P&Z CASE # P2021-001 P&Z DATE 02/9/21 CC DATE 02/16/21 APPROVED/DENIED

P2021-001- LOTS 1-7, BLOCK A, SKY RANCH ADDITION  
PRELIMINARY PLAT - LOCATION MAP =

# PRELIMINARY PLAT SKY-RIDGE ADDITION

**TO:** Planning and Zoning Commission  
**DATE:** February 9, 2021  
**APPLICANT:** Bill Thomas; *Engineering Concepts and Design, LP*  
**CASE NUMBER:** P2021-001; *Preliminary Plat for Lots 1-7, Block A, Sky Ridge Addition*

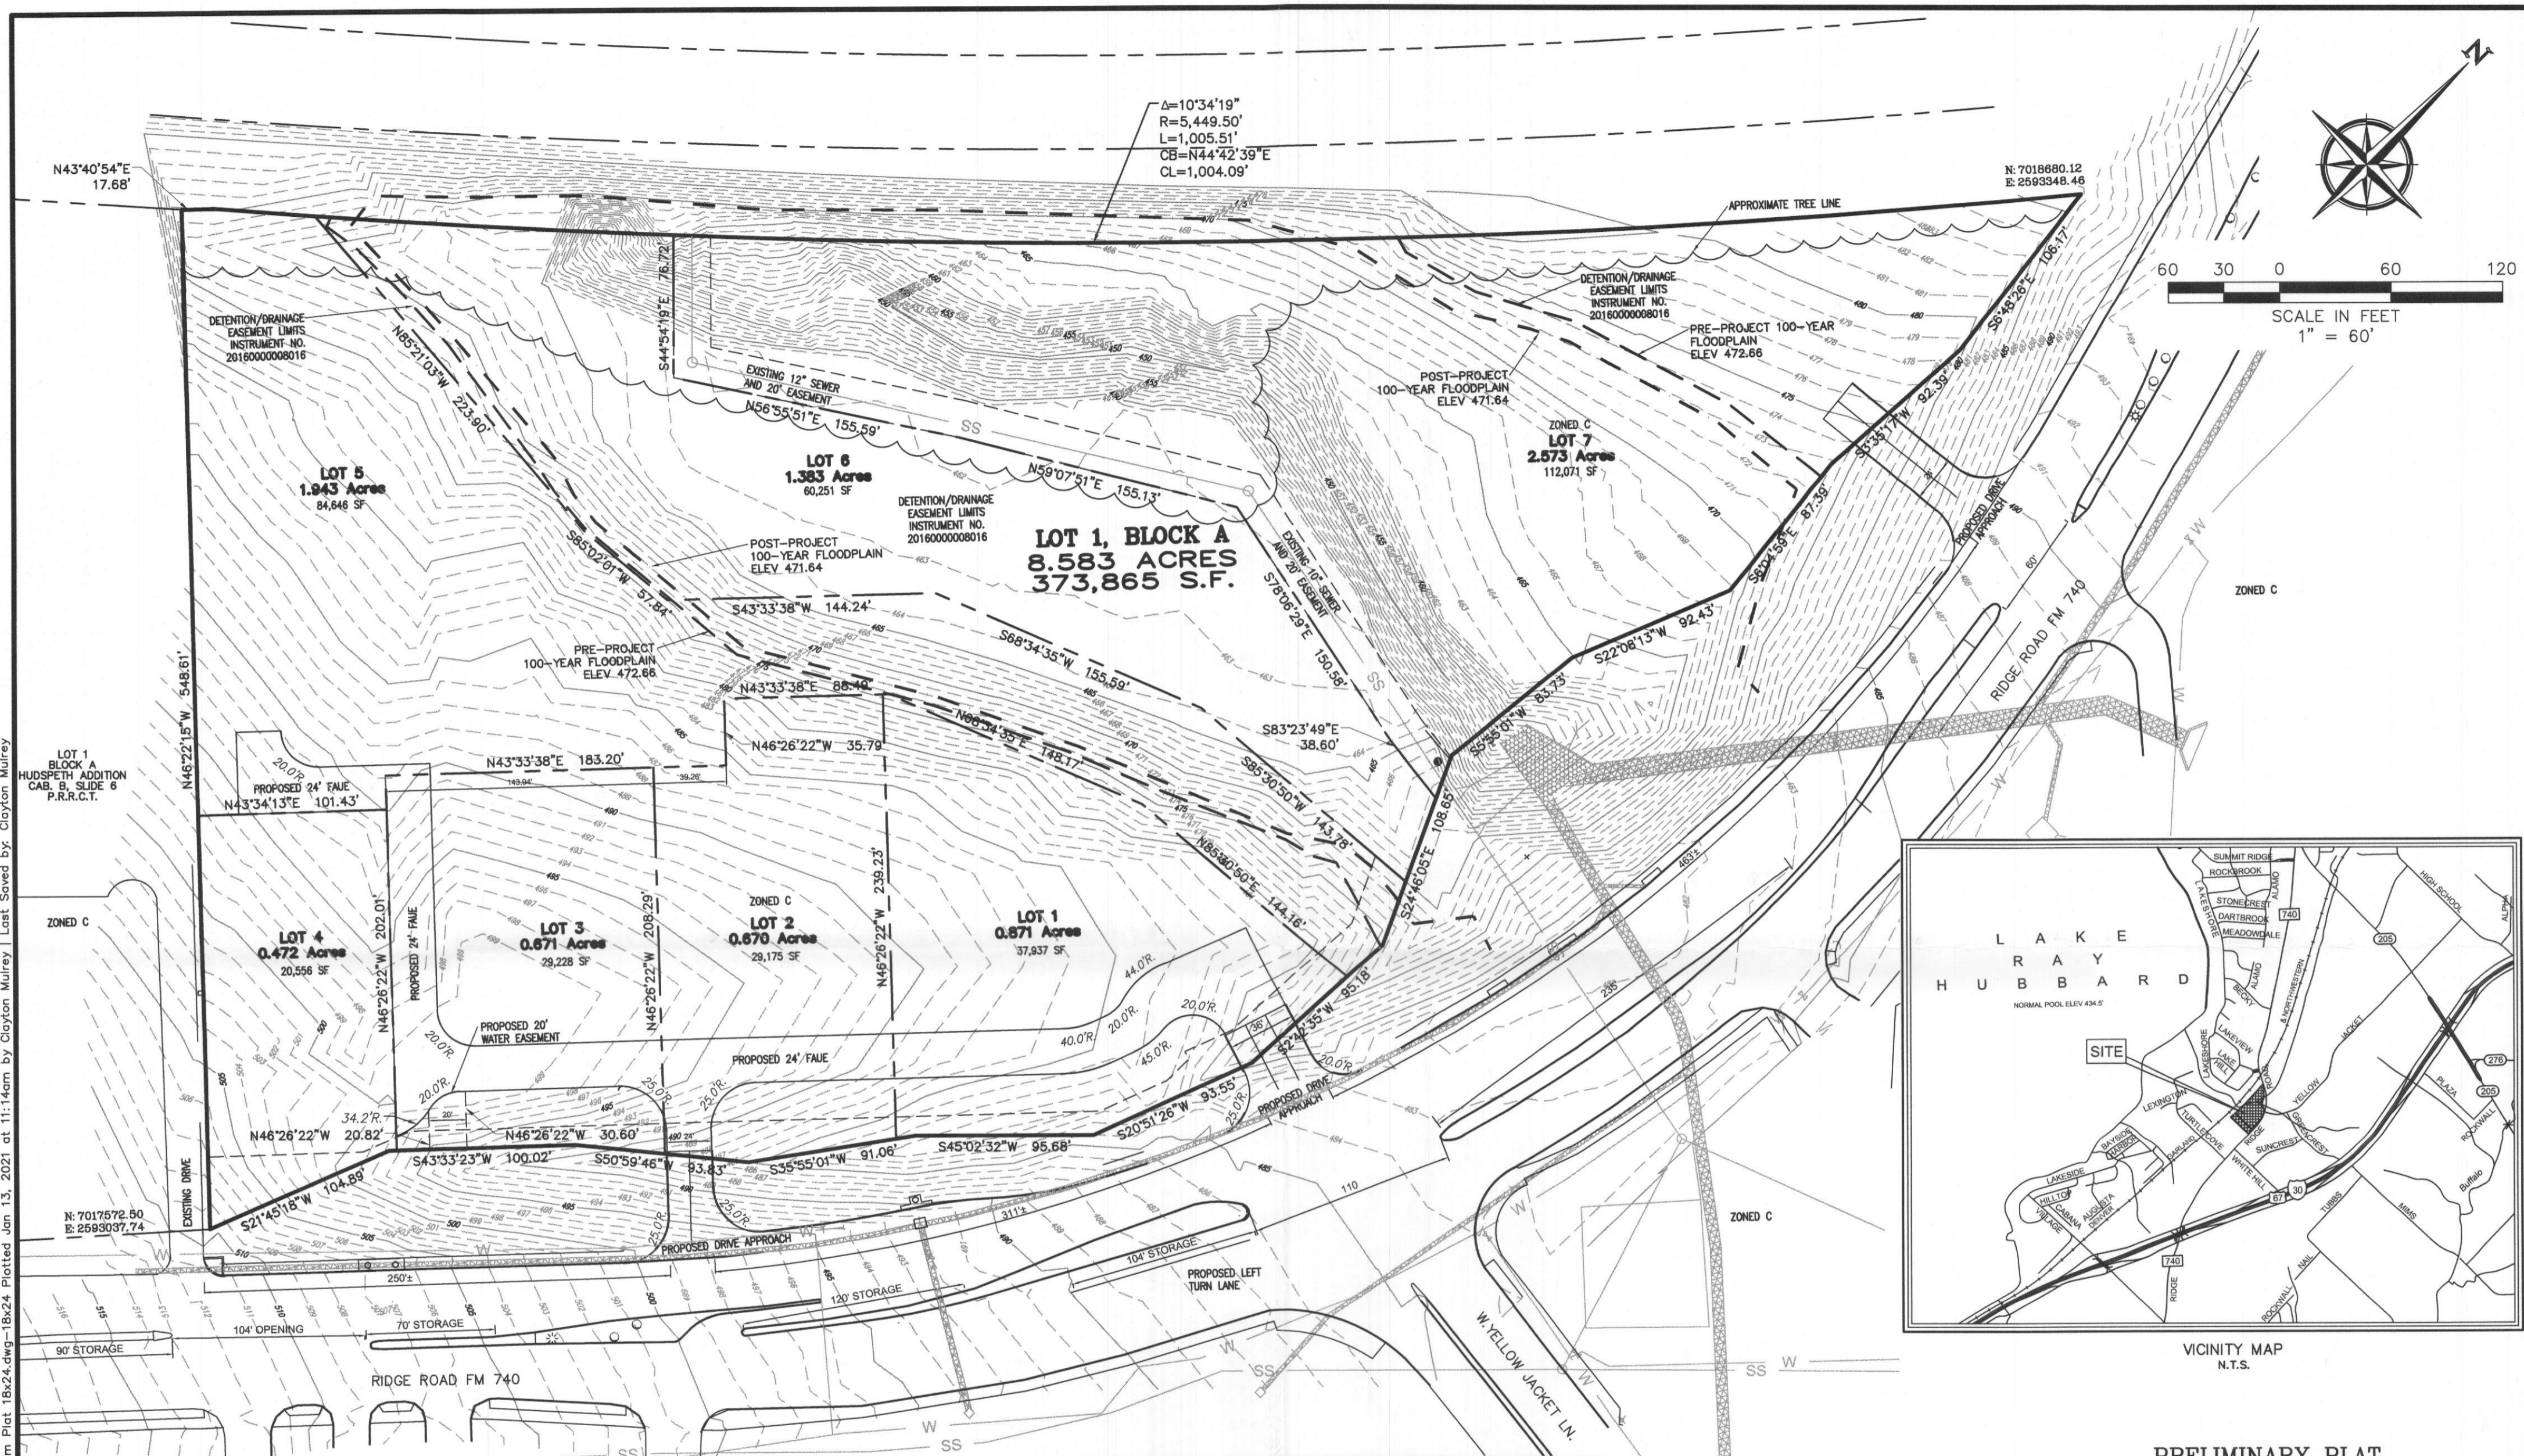
01/21/2021: M - Must show existing and proposed utilities.

Must show existing and proposed utilities on site in case additional easements are required.

- Fire lane to be in a platted easement.
  - TIA per TXDOT requirement for Ridge Road (FM 740) or revise the existing one to reflect drive through restaurant and resubmit to TXDOT and the City for approval.

**PRELIMINARY UTILITY PLAN**  
SKY-RIDGE ADDITION  
CITY OF ROCKWALL  
ROCKWALL COUNTY, TEXAS

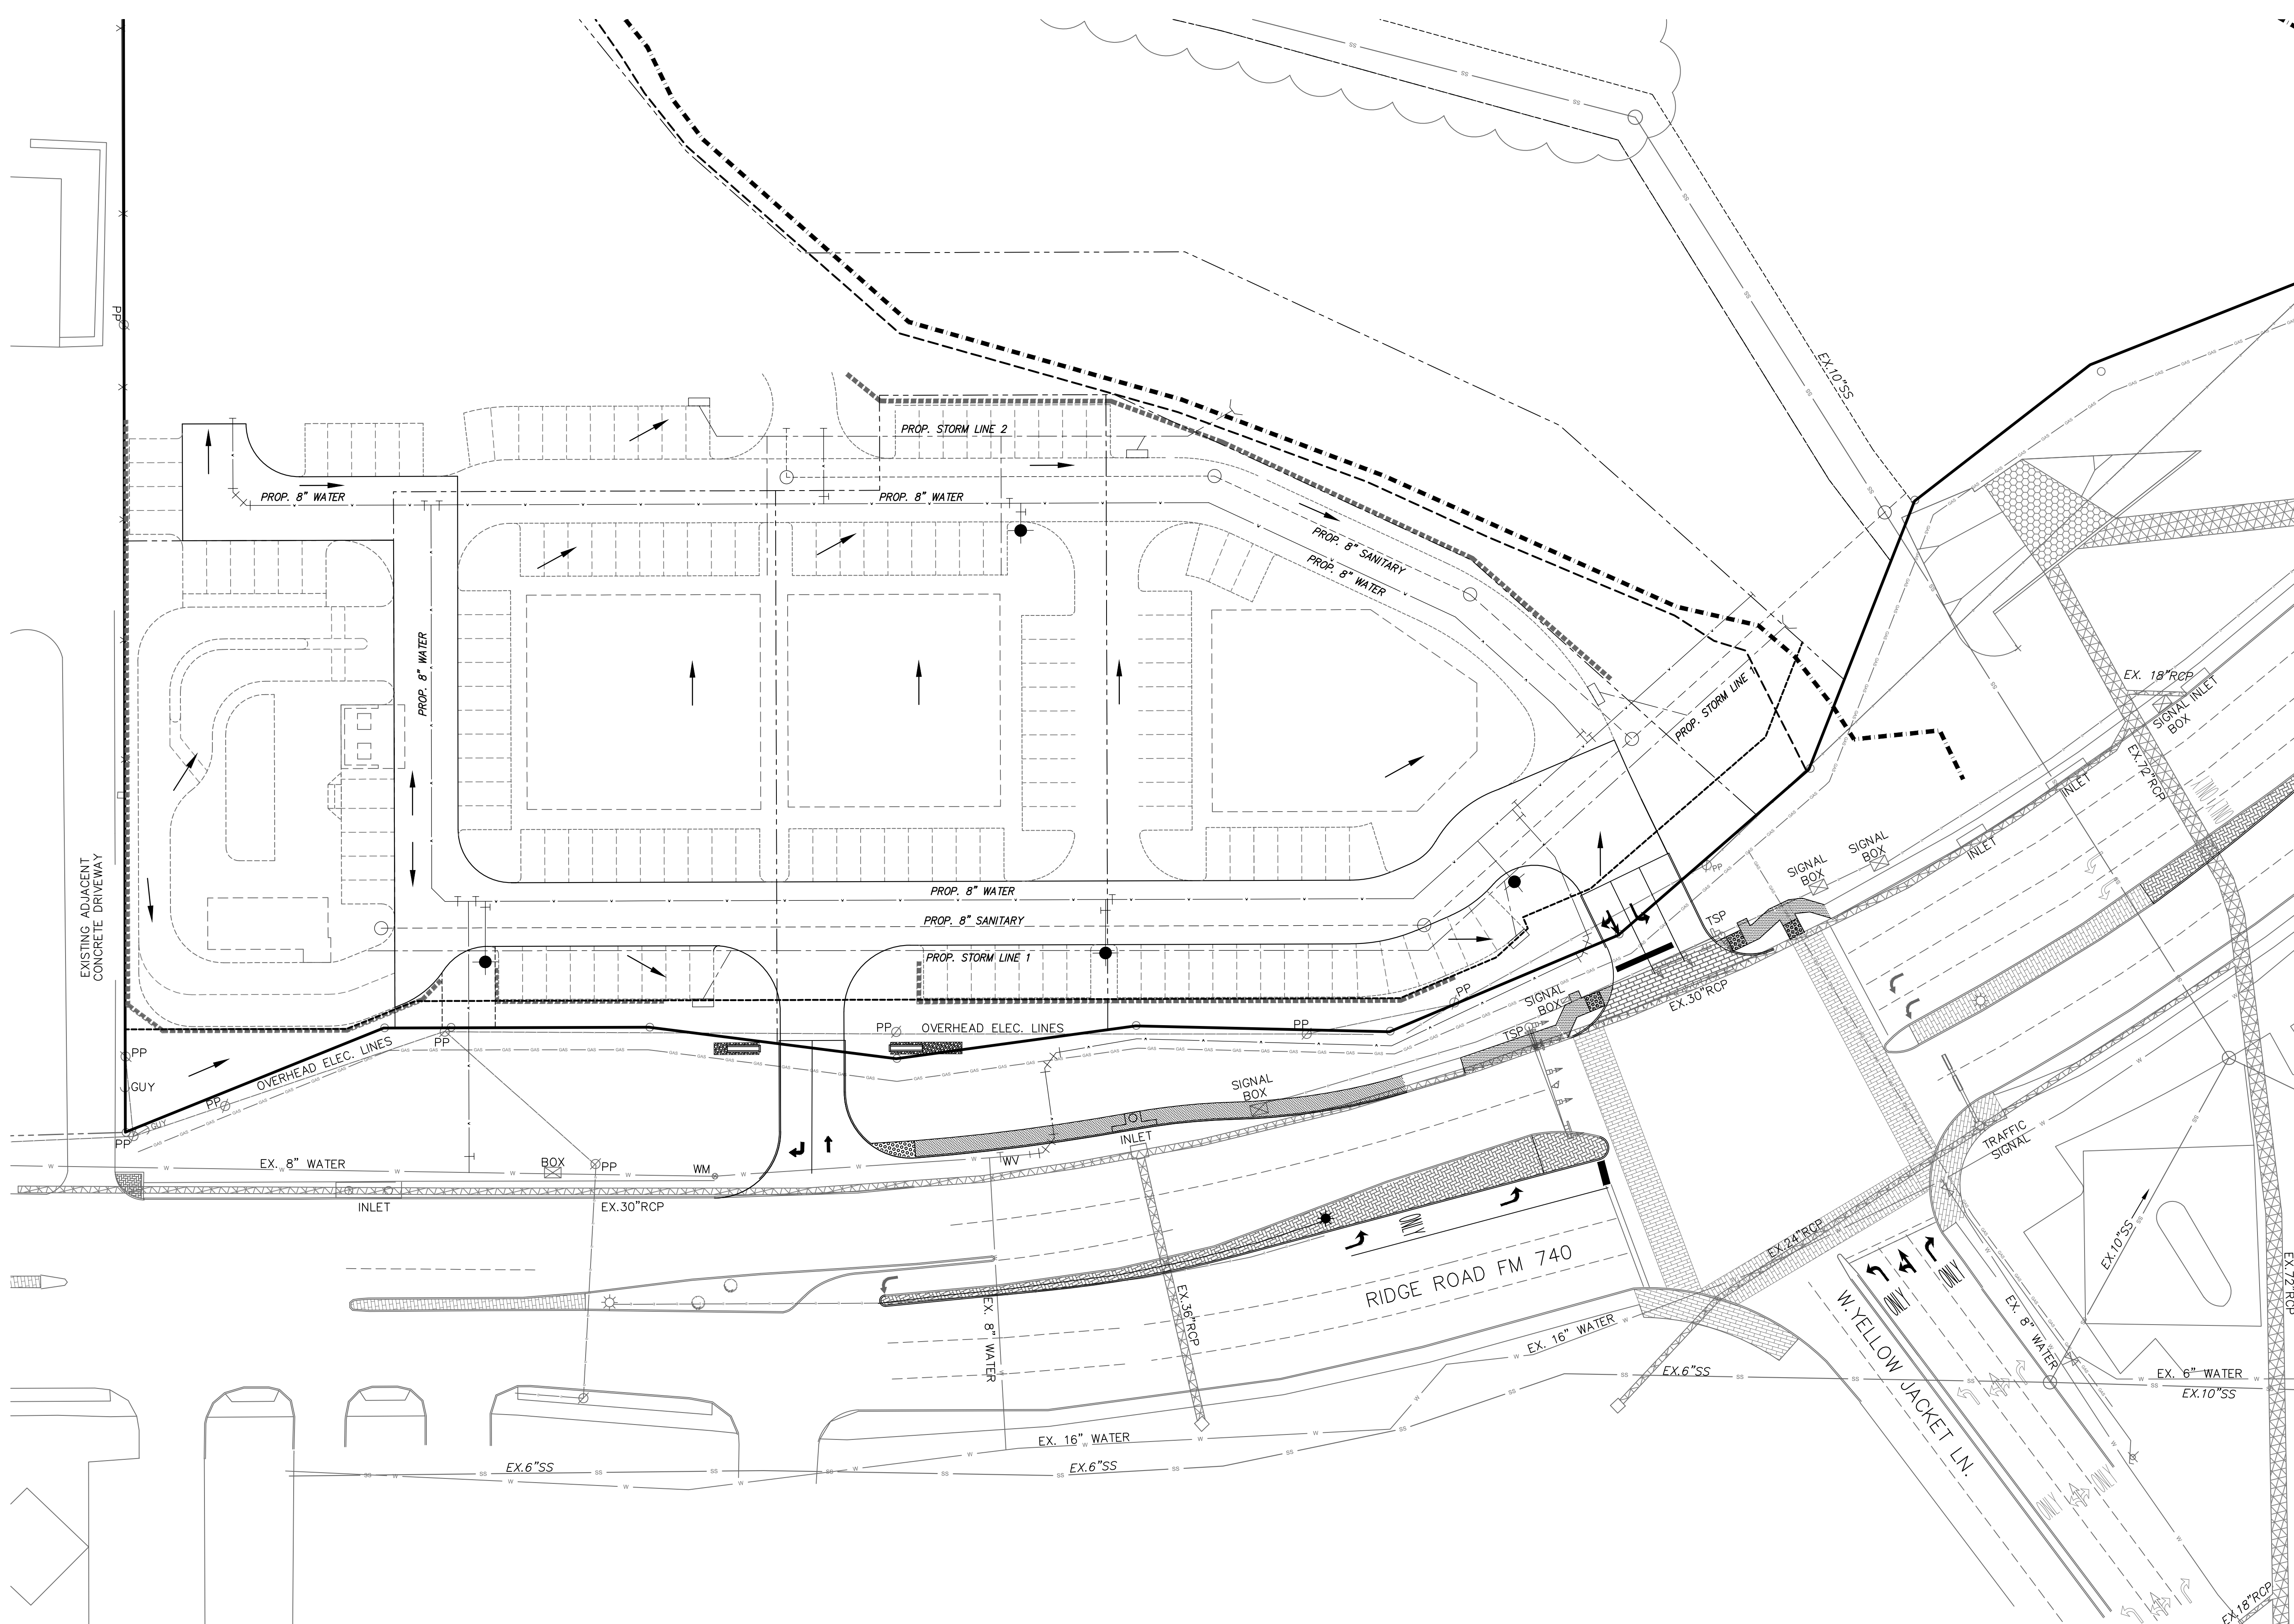
- M - Must label all fire lane/drive isle radii.
- M - Must show easements for public lines. Minimum easement width is 20' and all lines must have 10' of spacing from other parallel lines.
- M - Fire hydrant cannot be directly over the storm lines.
- I - Drainage plan and calculations were not reviewed.
